MULTIPLE SEWERSHED PACKAGE 10B – OPEN CUT
Solicitation Number: CO-00285-SM
Job No.: 18-4542

ADDENDUM 1
08/23/19

DEVINE SANITARY IMPROVEMENTS STA 9+00 TO STA 13+00

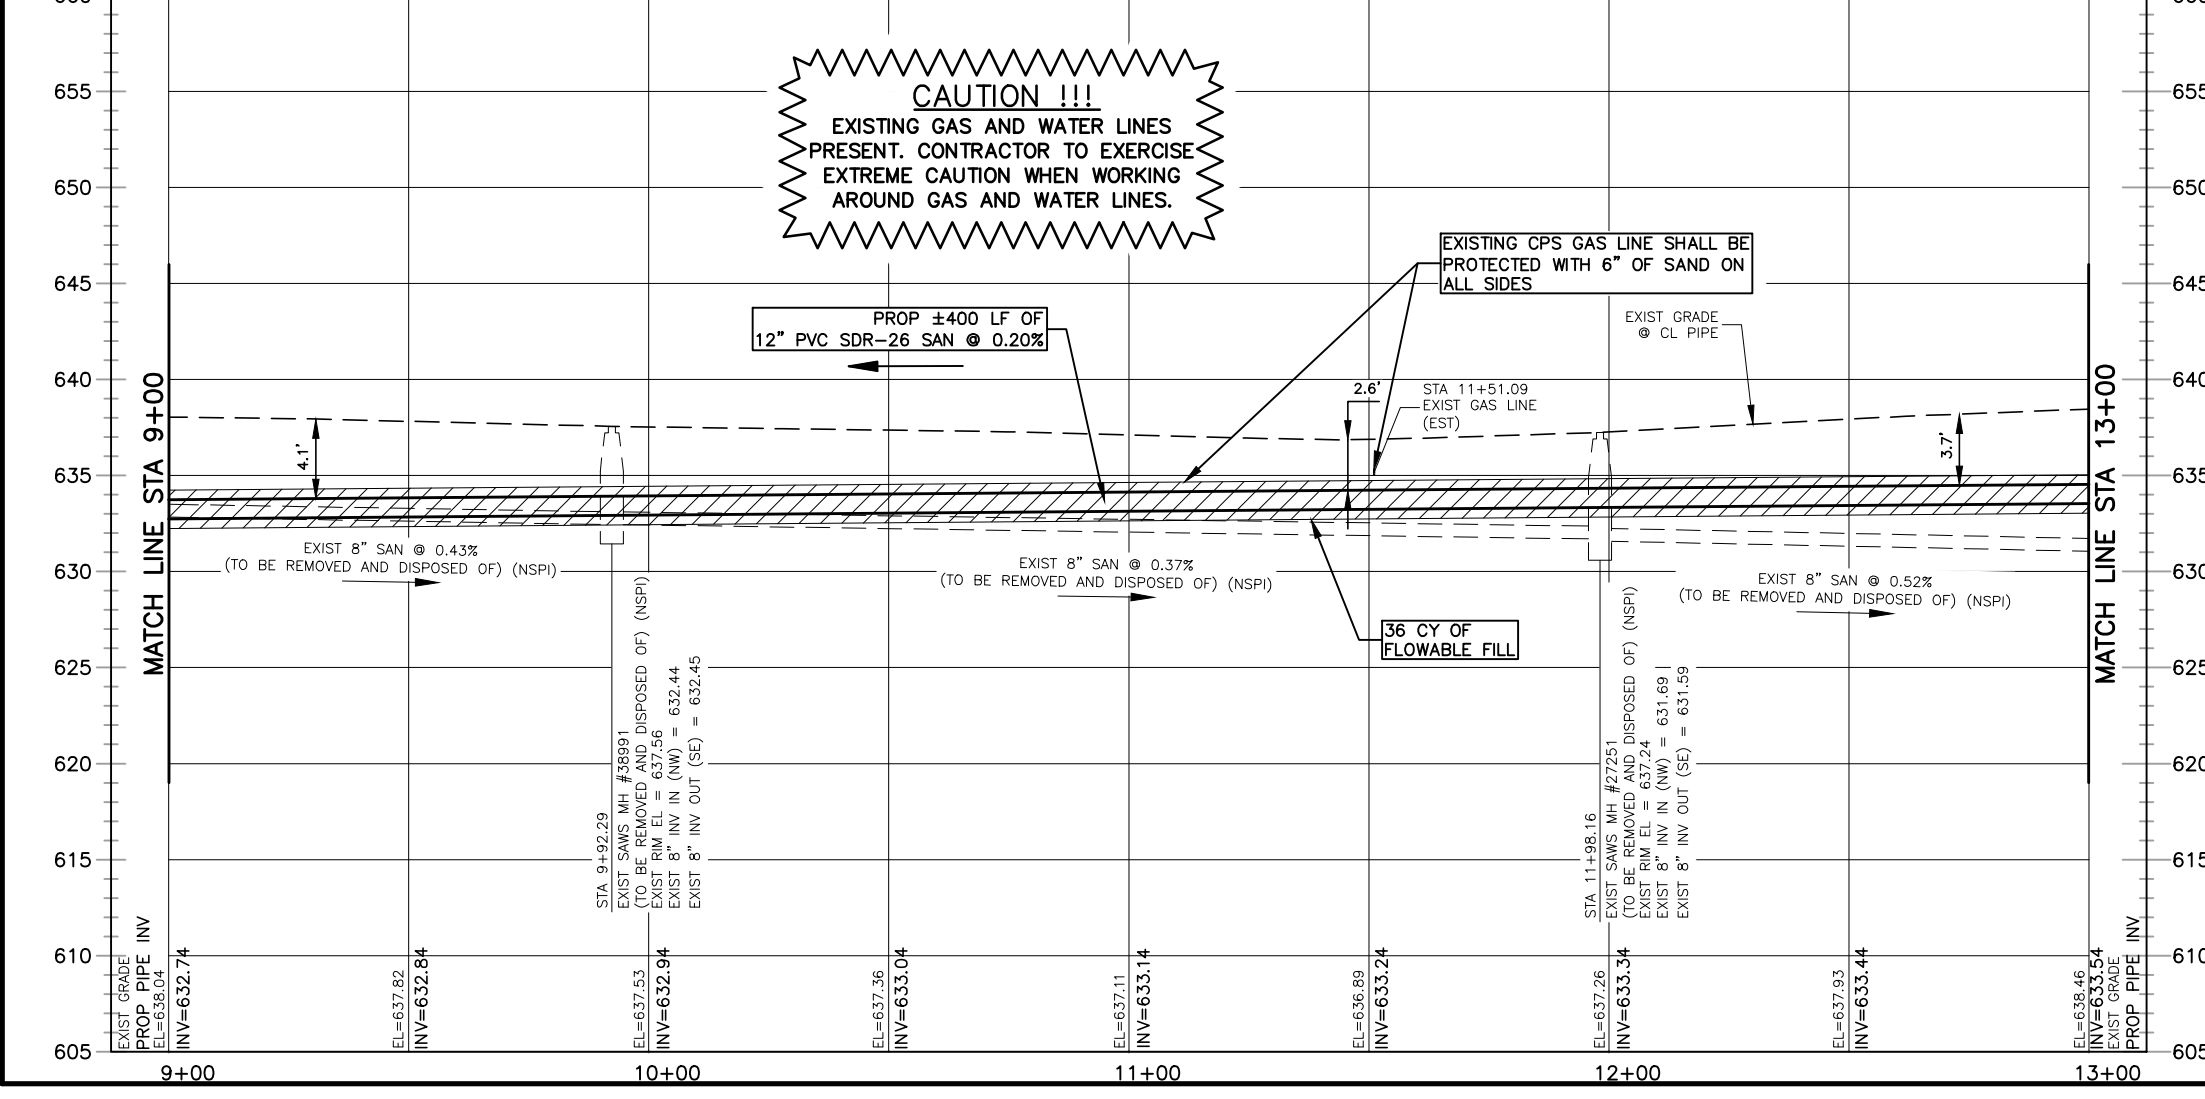
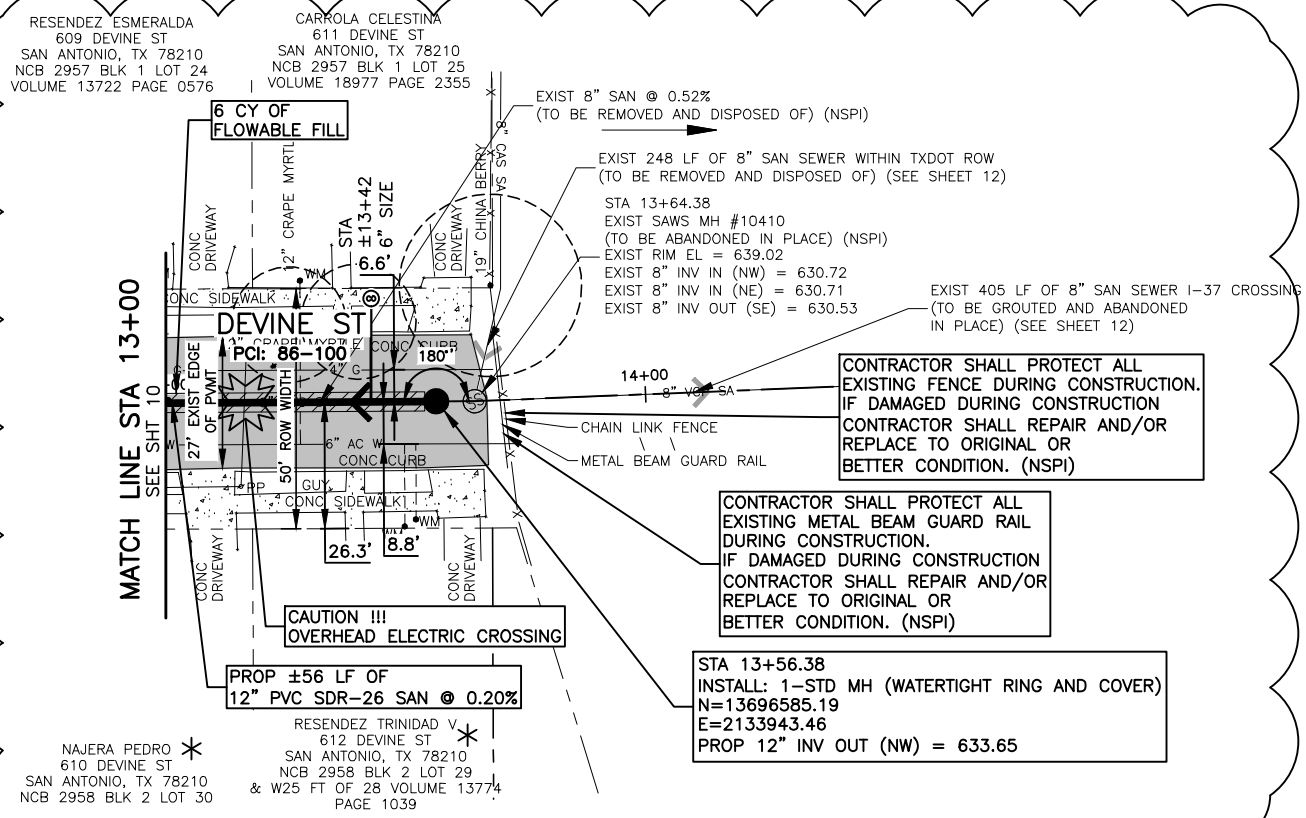
8. DELETE **Sheet 10 of 28** of the SEWER PLANS in its entirety and REPLACE with the attached **Sheet 10 of 28**, dated 8/21/19. Sheet 10 has been revised to show updated tree species and/or location.

SHEET 11 OF 28

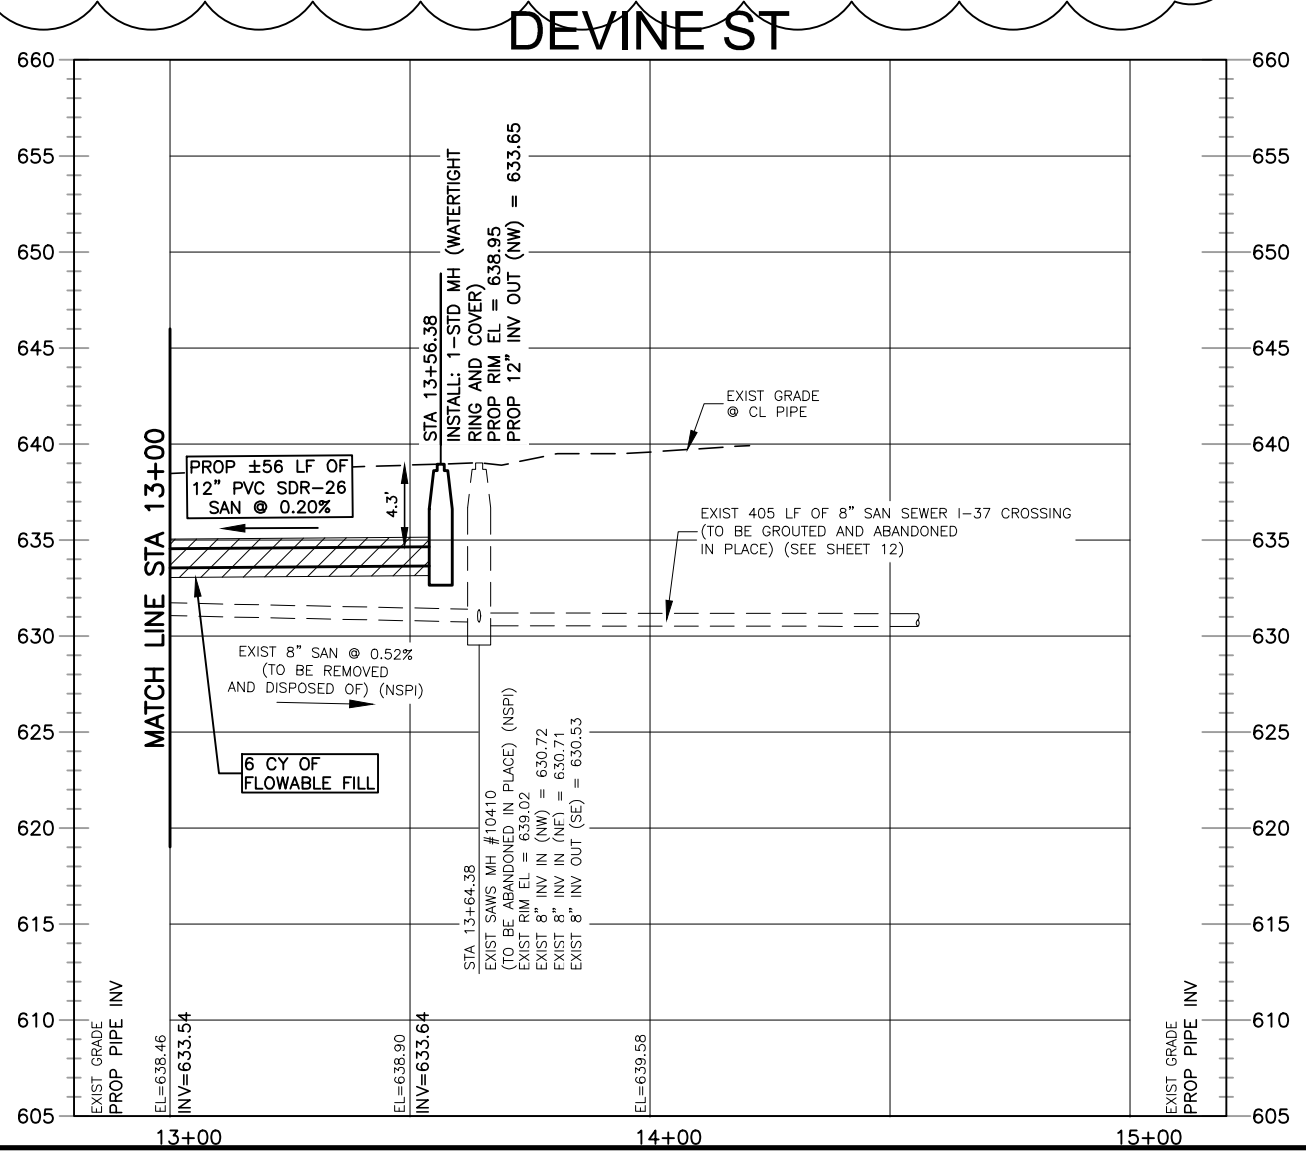
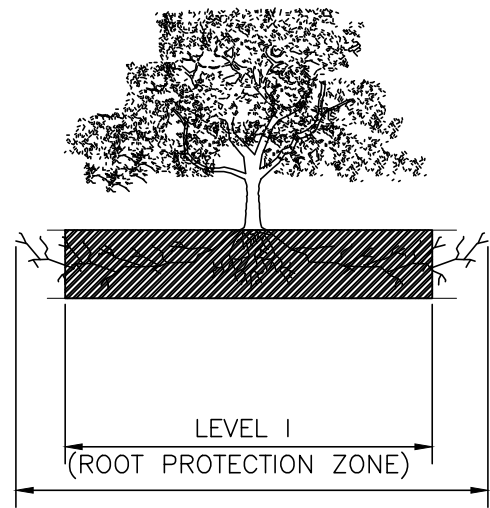
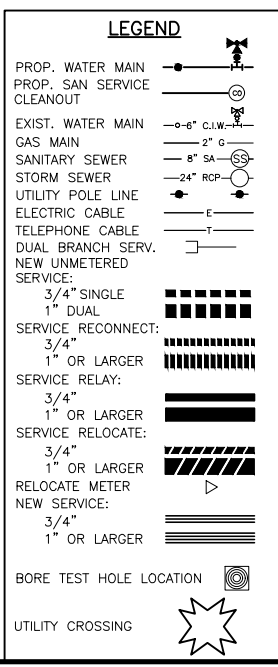
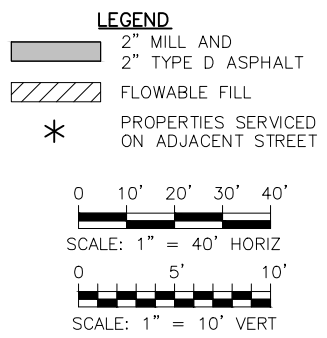
9. DELETE **Sheet 11 of 28** of the SEWER PLANS in its entirety and REPLACE with the attached **Sheet 11 of 28**, dated 8/21/19. Sheet 11 has been revised to show updated tree species and/or location.
